**Southern
Water**

Your ref
BN/112/20/EIS

Proposal: Environmental scoping opinion for up to 1500 dwellings, community facilities, local centre (shops and services), a primary school and associated playing fields and early years provision (nursery).

Site: BN/112/20/EIS: - Land at Barnham, Eastergate and Westergate, PO22 0ED.

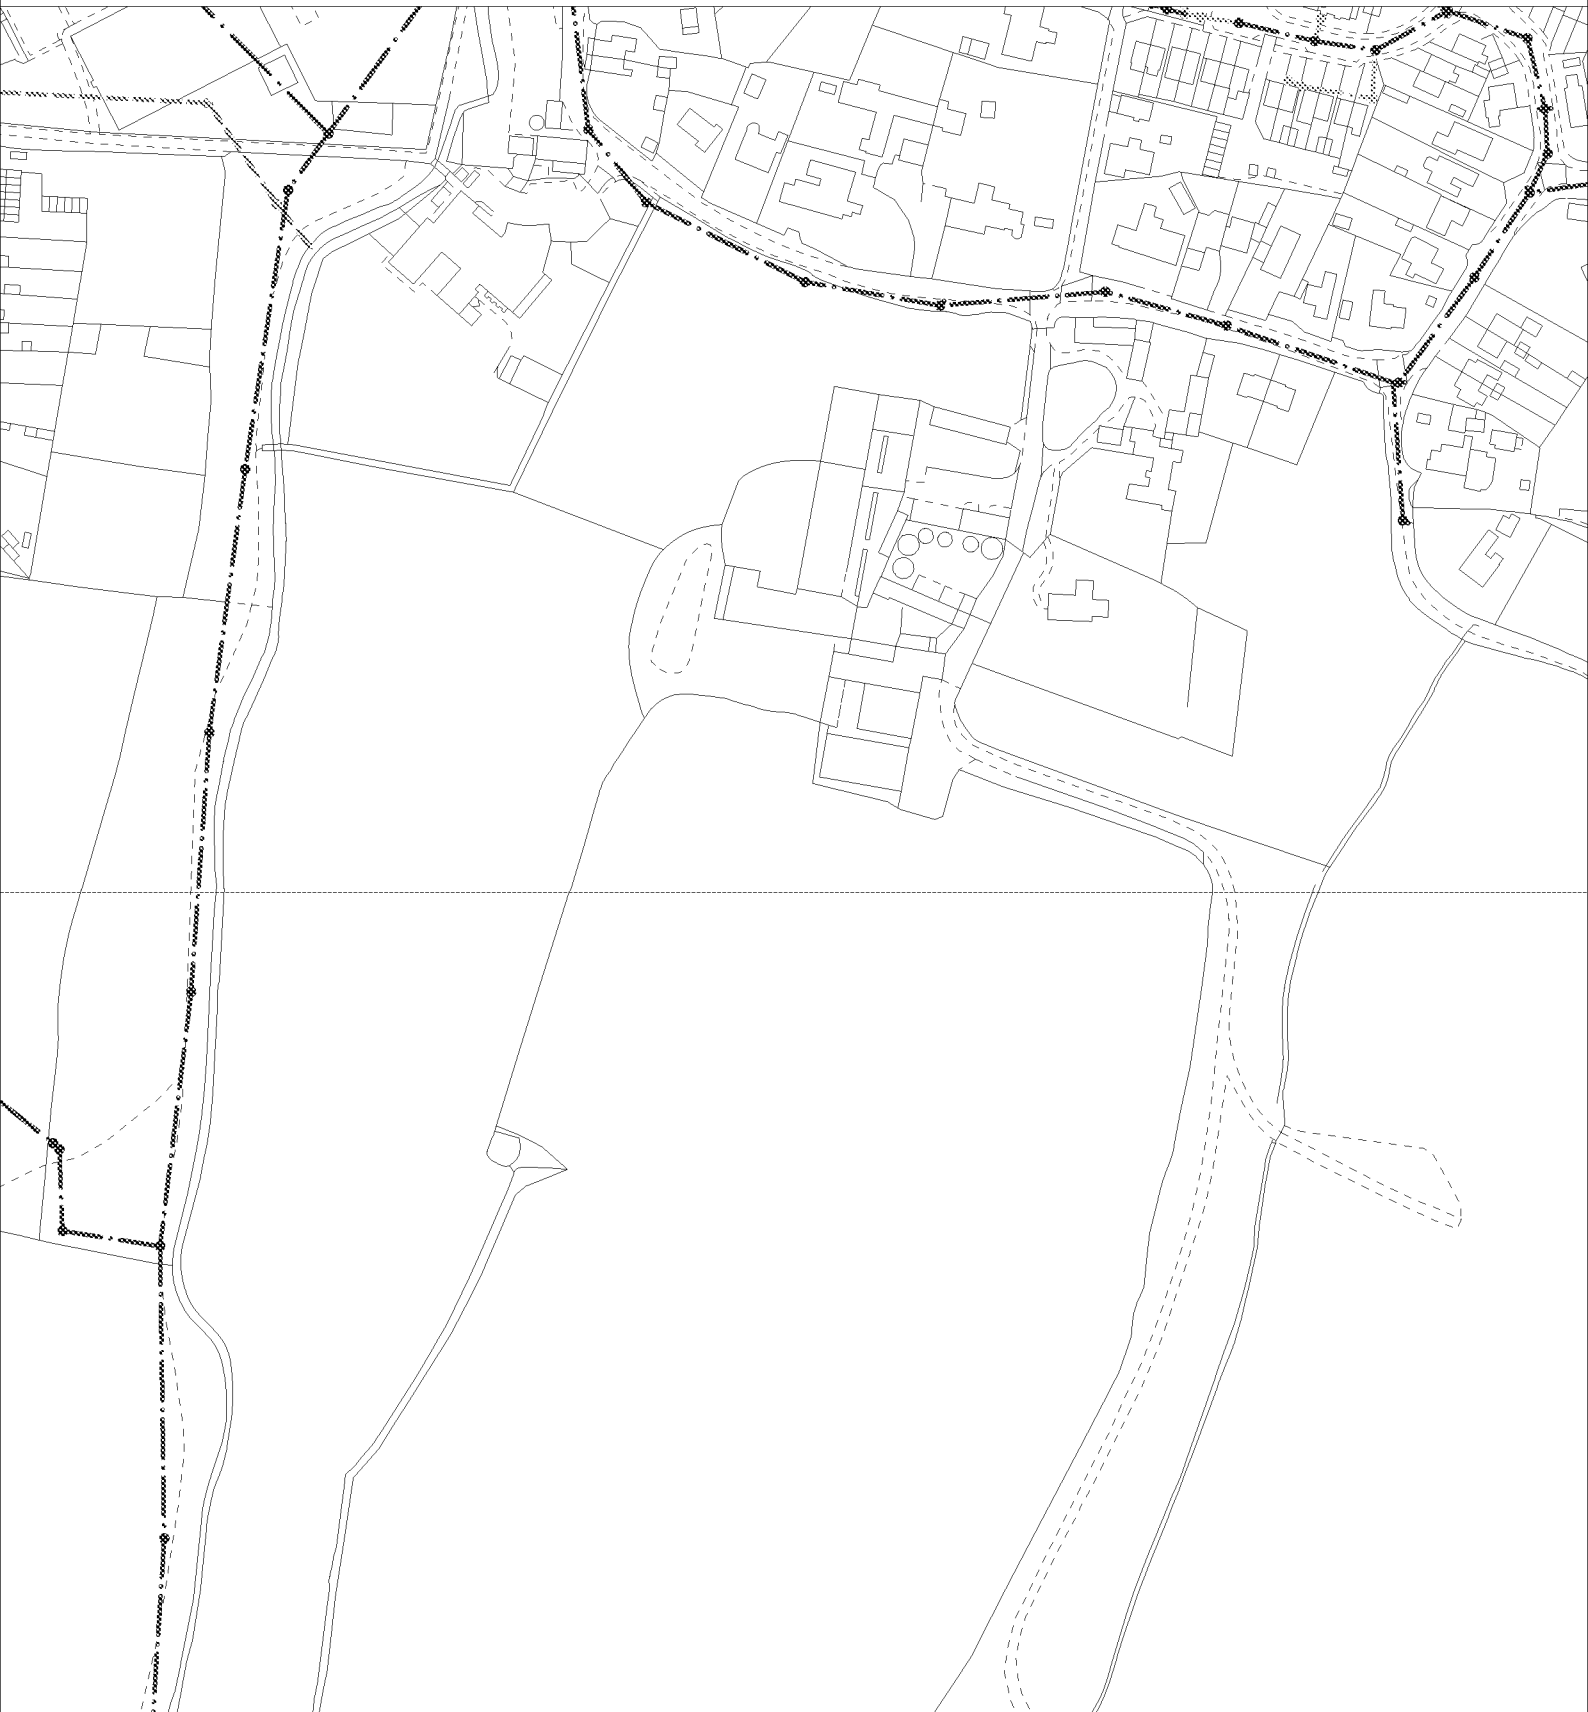
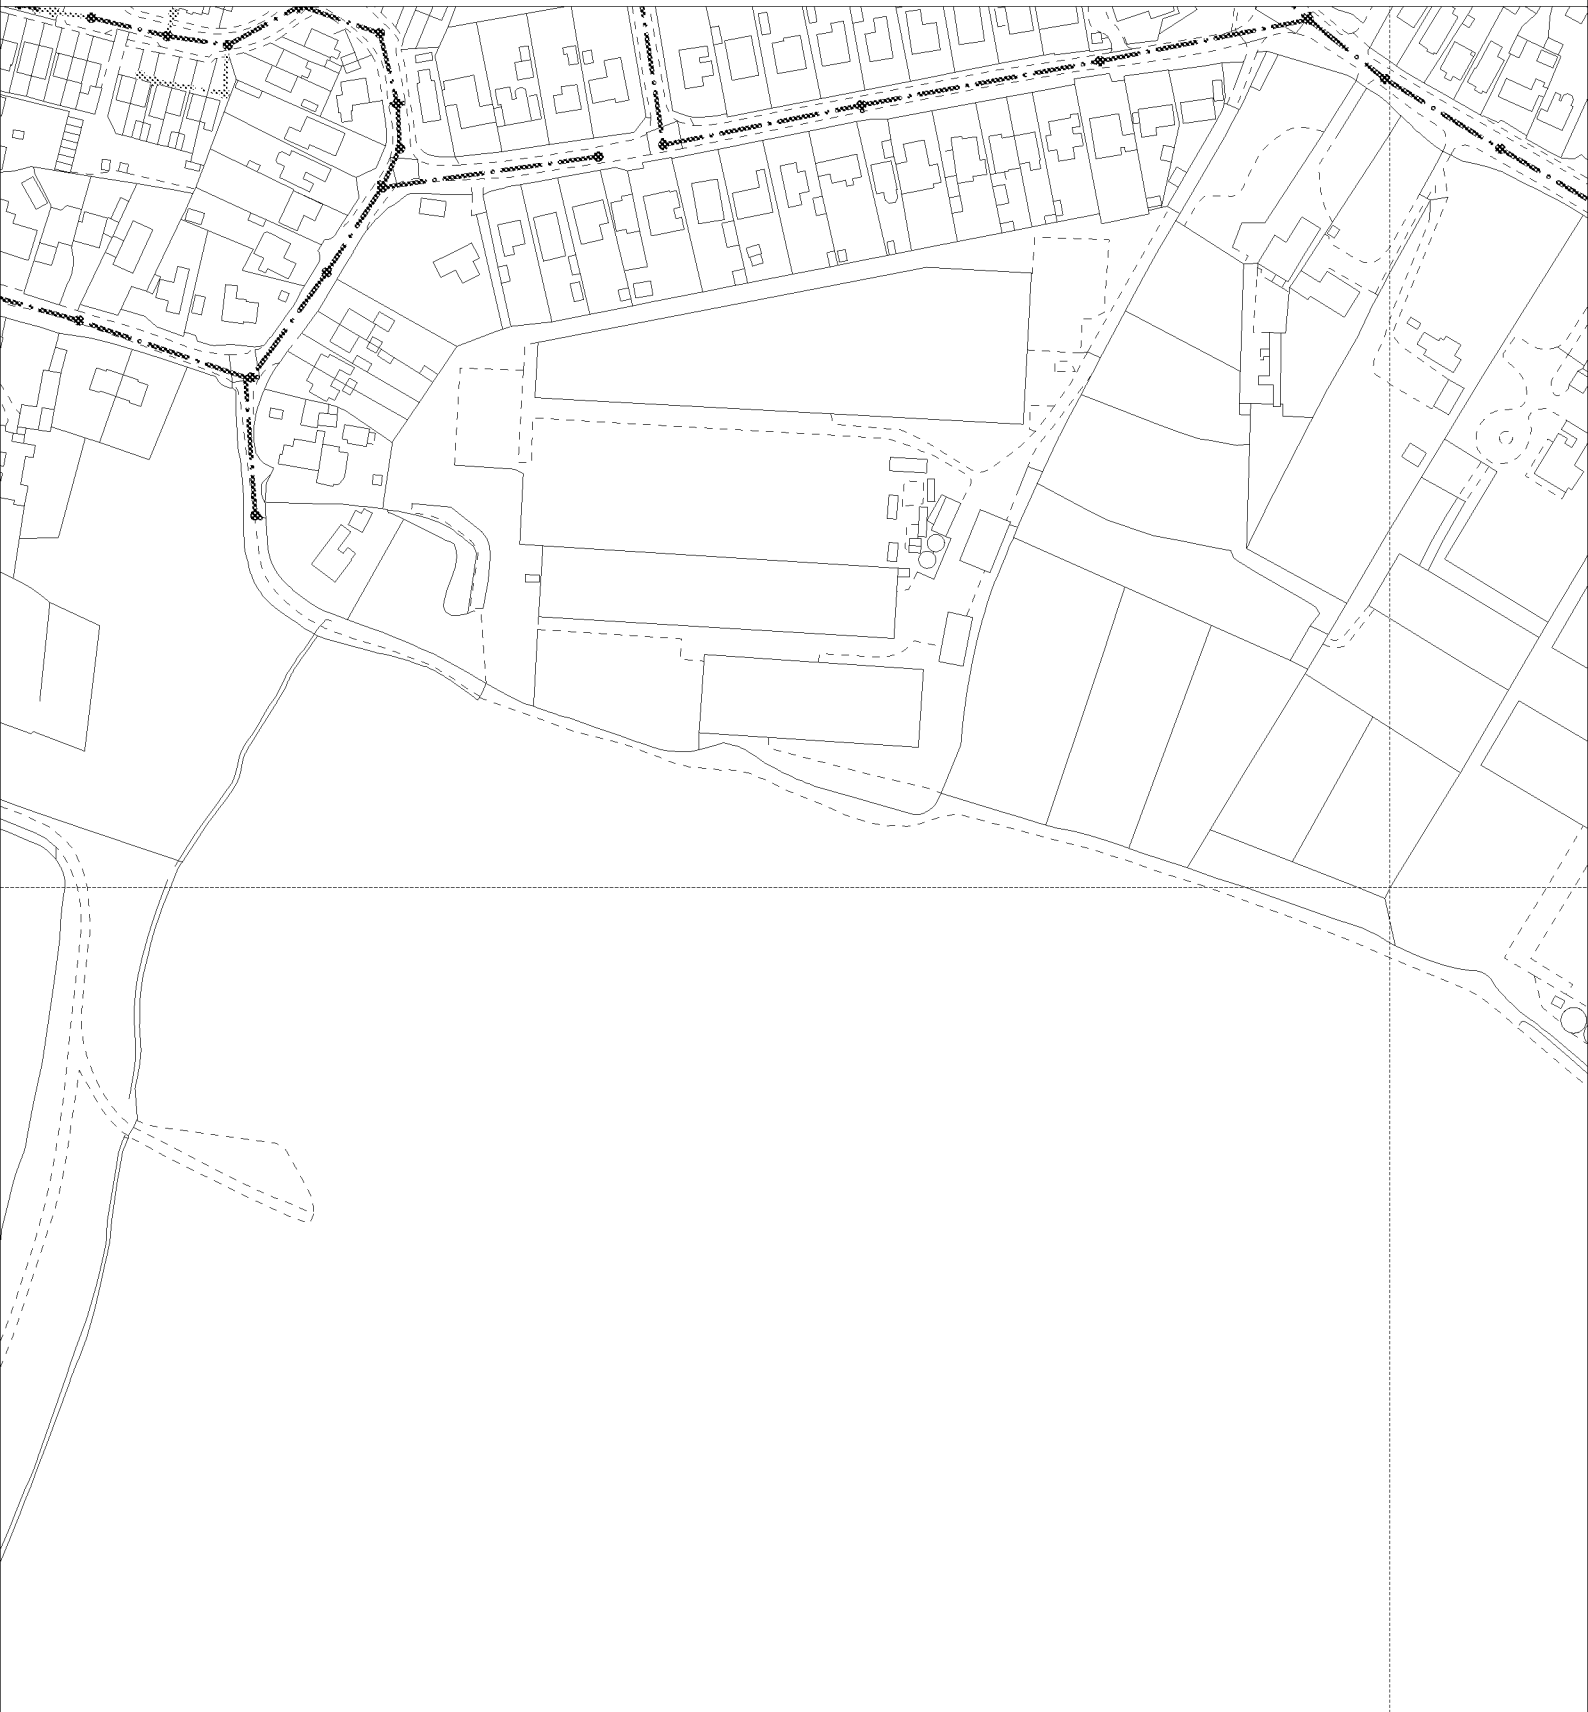
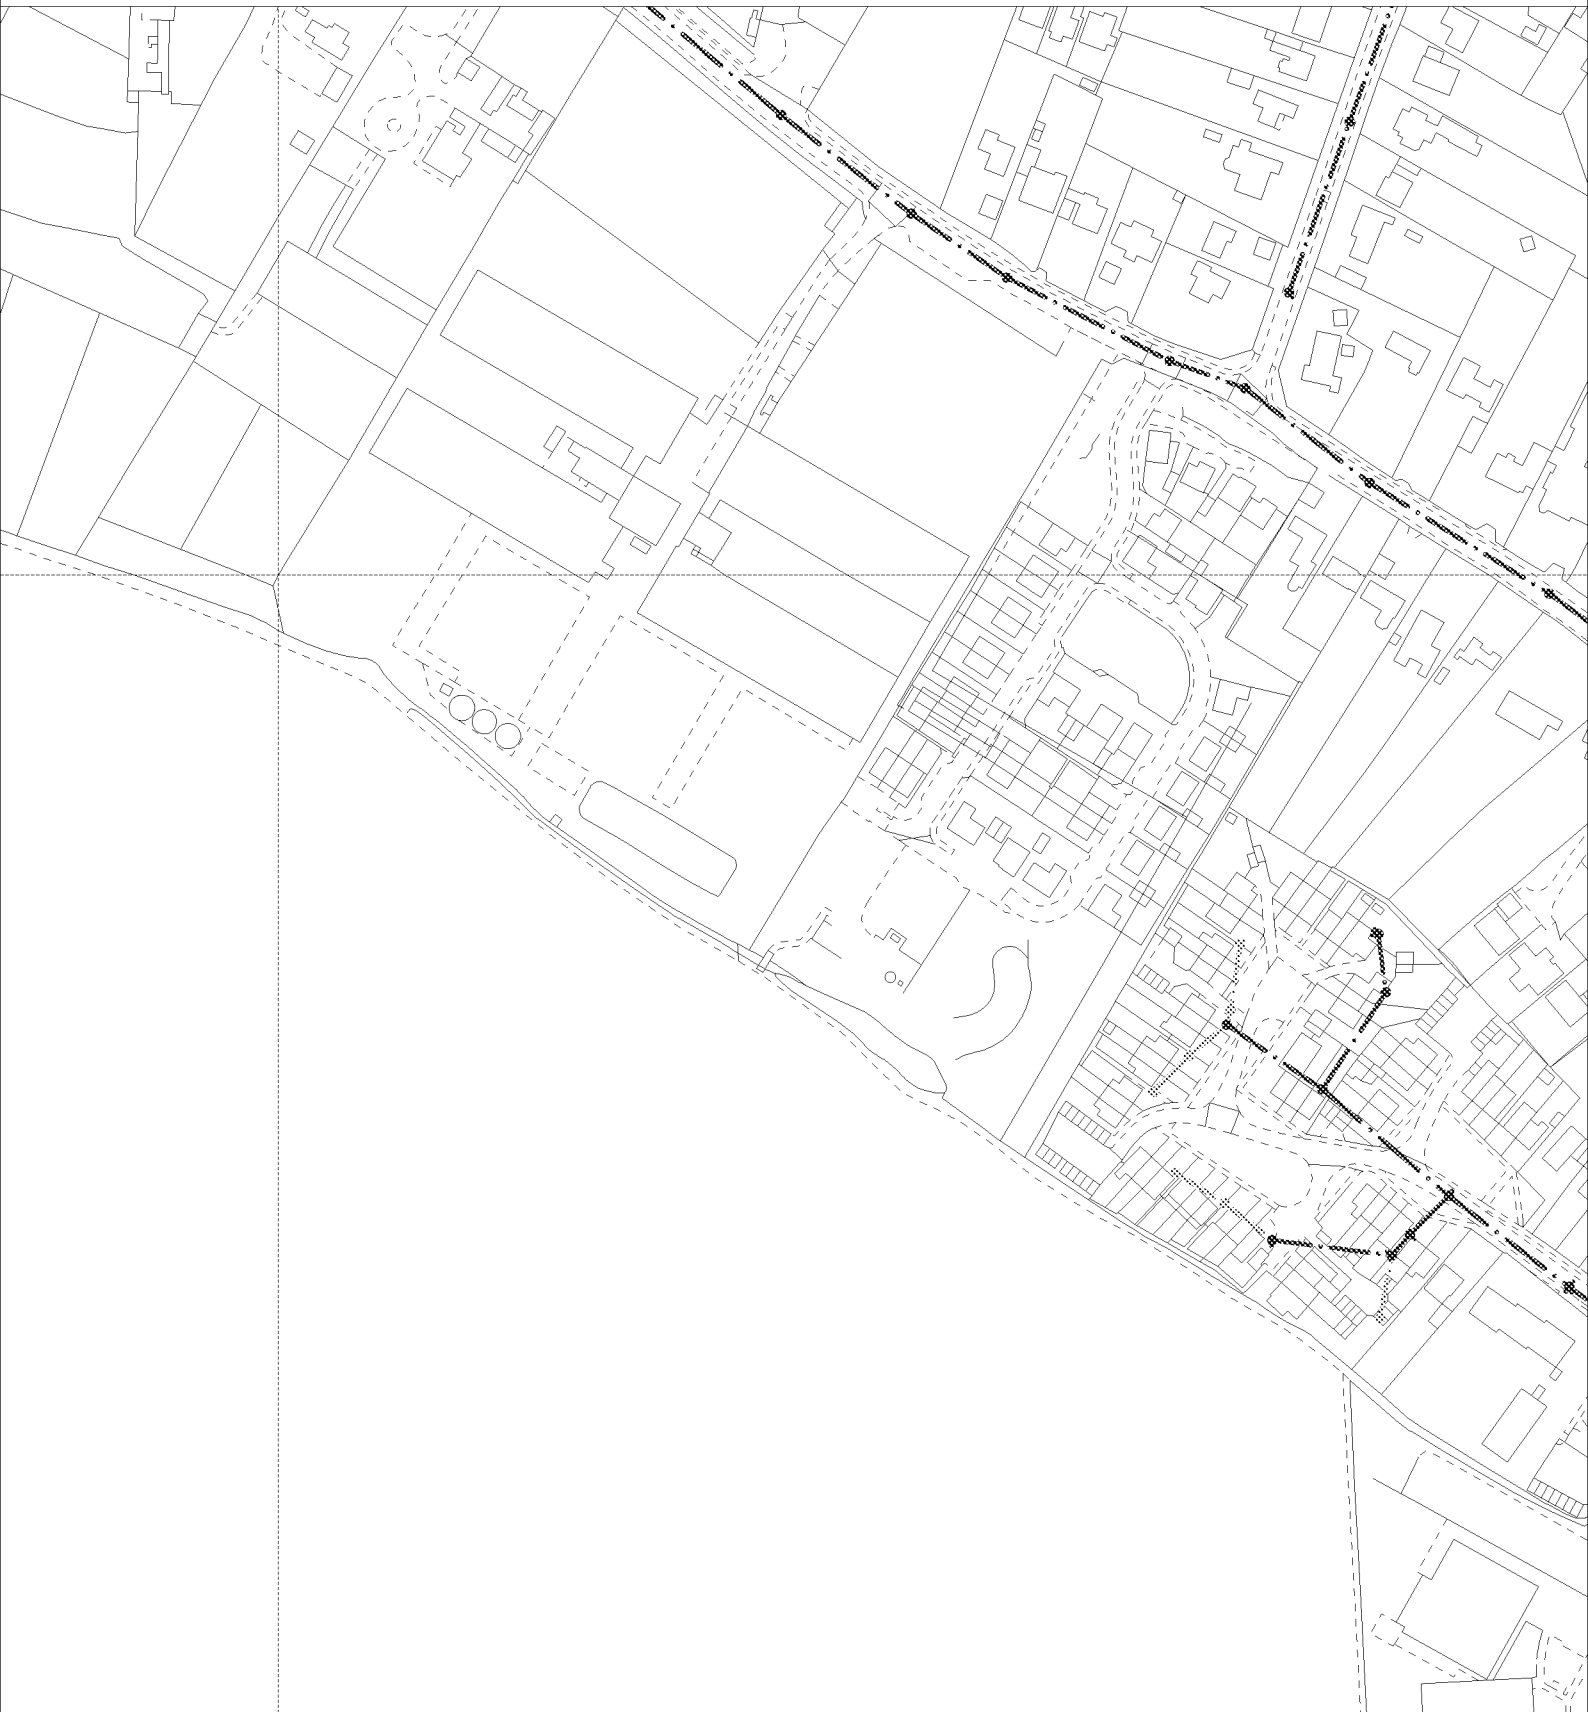
- Southern Water's current sewerage records show that there are foul sewers within the proposed development site/s. No new development/building works will be permitted to be constructed over or within 3.0 metres of the existing foul sewers. Sewer record attached for your information.
